ACT
Government

COMMUNITY WORKSHOP NO.2

Haig Park Masterplan Development

Our Purpose: To seek feedback on the themes, objectives and principles for the masterplan to focus on.

PATHWAYS PLANS

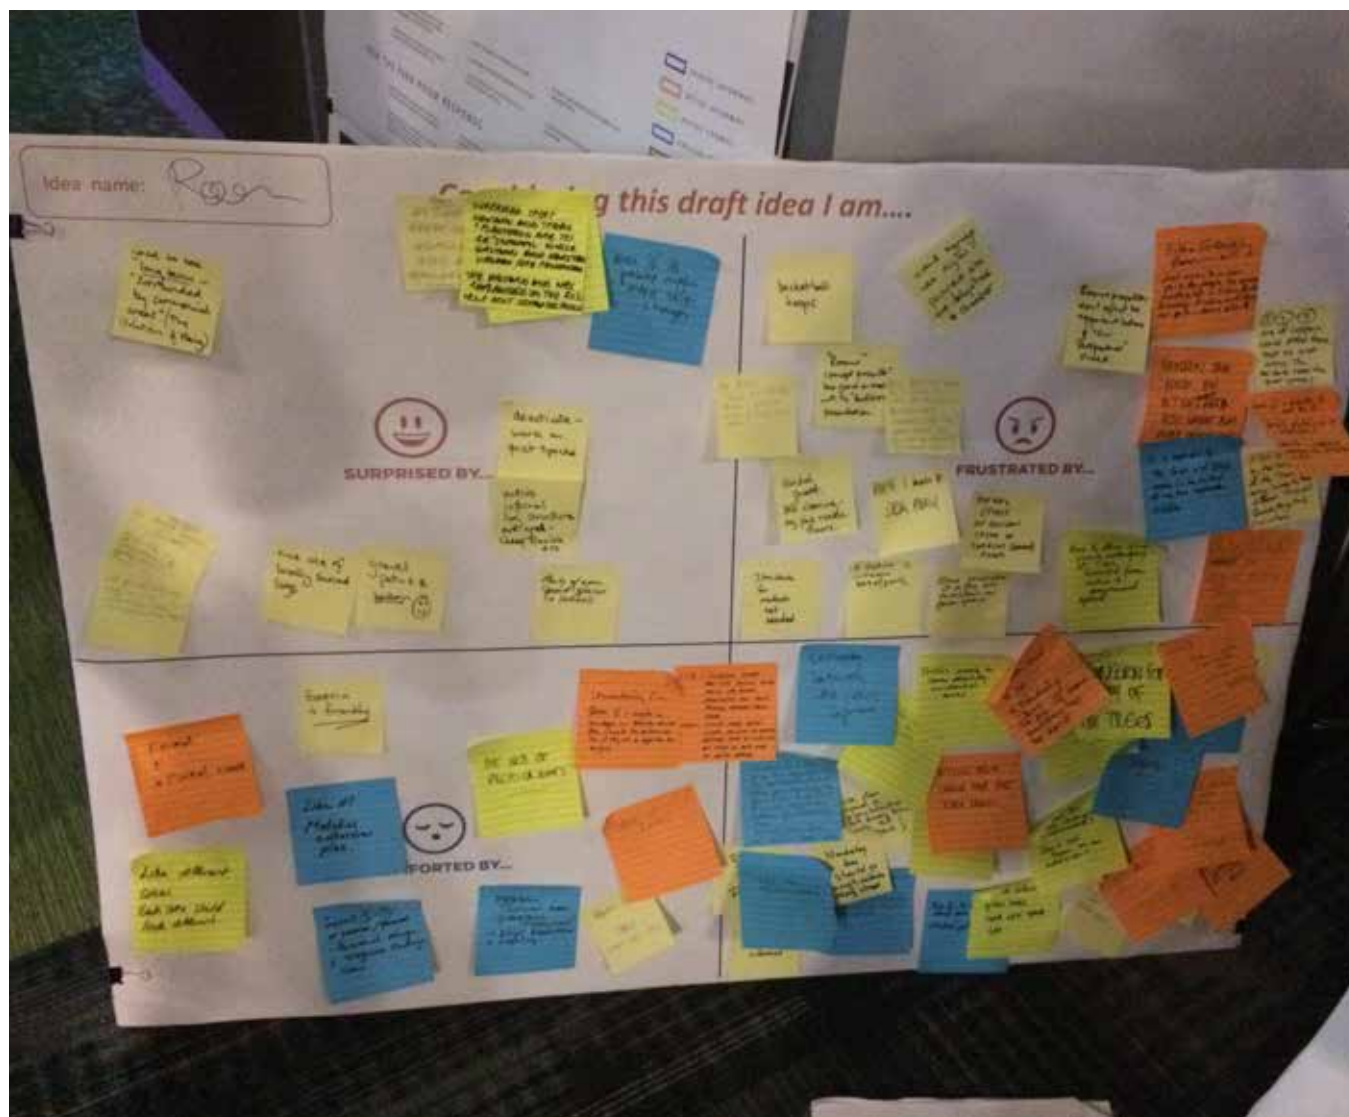
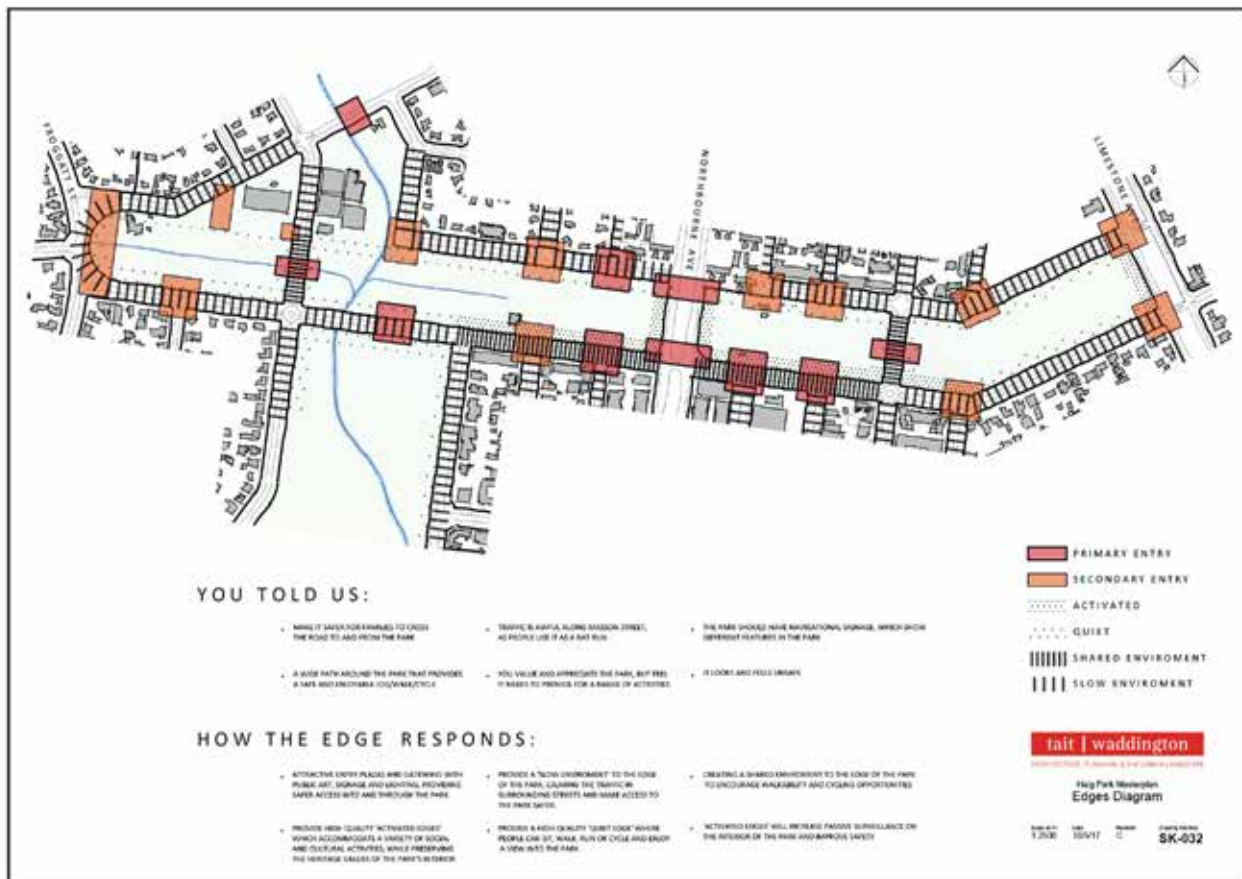
Love the idea of a wide shared pathway along the long edges. Love the idea of linear plazas on the eastern side of Northbourne.

We don't need a fat track around Haig Park I love the curve of footpaths, it shows peoples foot traffic and desire.

No paths that impact trees.

Putting shared pathways through the centre of the path (parallel to Masson and Girrawheen) would completely remove quiet spaces of the park - please keep them to the edges.

Surprised and don't like continuous shared network (doesn't make sense).

Shared network not to be hard surface around 9 and 10.

Linear plaza looks too formal. Who wants to walk around the edge of Haig Park? Why ignore the desire lines?

Please consider introduction of a formalised desire line centrally, running east to west in all the park zones.

Key safe crossing point missing - on Girrawheen St. where the pathway through to Farrer St. emerges.

No. 4 park street too much!

EDGES PLANS

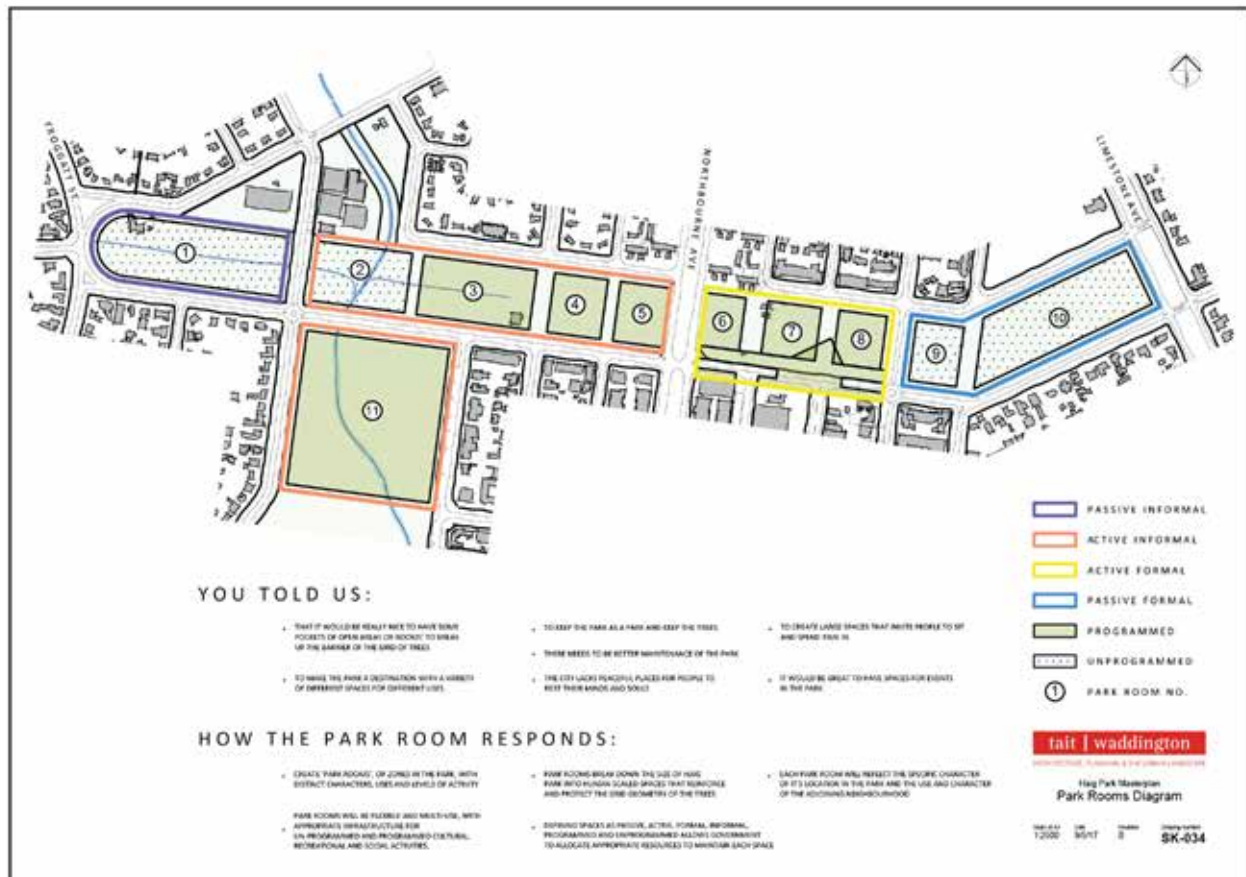
I don't see need for entry on McCaughey St north of Masson St - no path or anything for the entry to lead to, better at roundabout where the traffic is slowing anyway.

Far too many entries shown, will change character of the park, keep the edges natural.

Quiet edge 5 [photo] looks fantastic!

Main entries may be required for Mort St. there are too many other entries which are not required.

Too many entries. Need hierarchy.

Why is there a need for a gateway on Frogatt St, and in a number of other places?

Like 7 and 3 [photo] entry examples.

Very much like 3. Style secondary entries.

PARK ROOMS PLANS

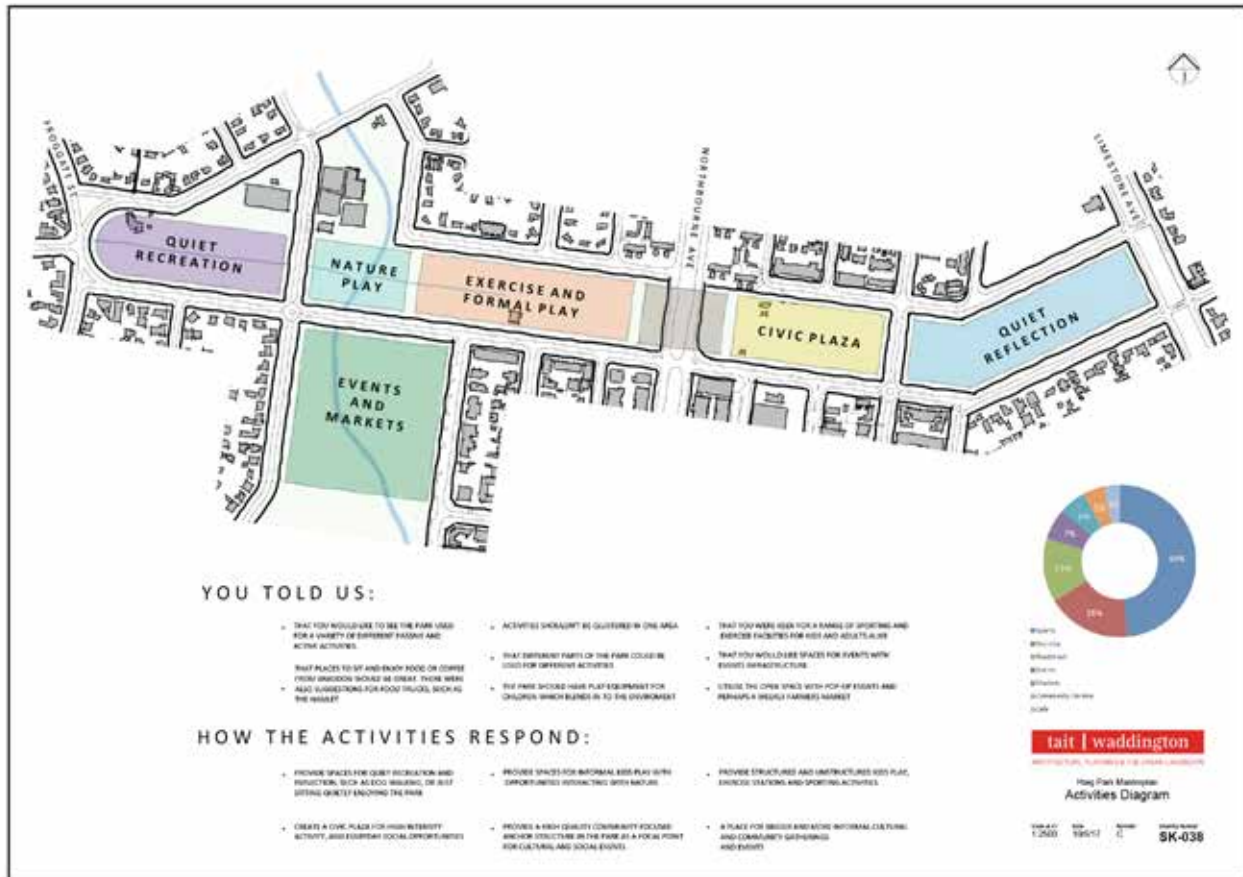
Surprised that western end trees and plantings are to be informal, while eastern end heritage values are recognised. The eastern end was replanted in the 80s, self govt stopped this process.

Space 2 already houses formal sporting activities and facilities so should possibly be active formal not active informal if those current facilities are to stay?

Incorporating part of Girraween St. into those adjacent rooms is a good idea.

Surprised that zone 1 is designated as low infrastructure passive informal yet the childcare at Ormond St could benefit from kid friendly infrastructure.

Section 10 concrete path not covered in plan.

I like park room 3.
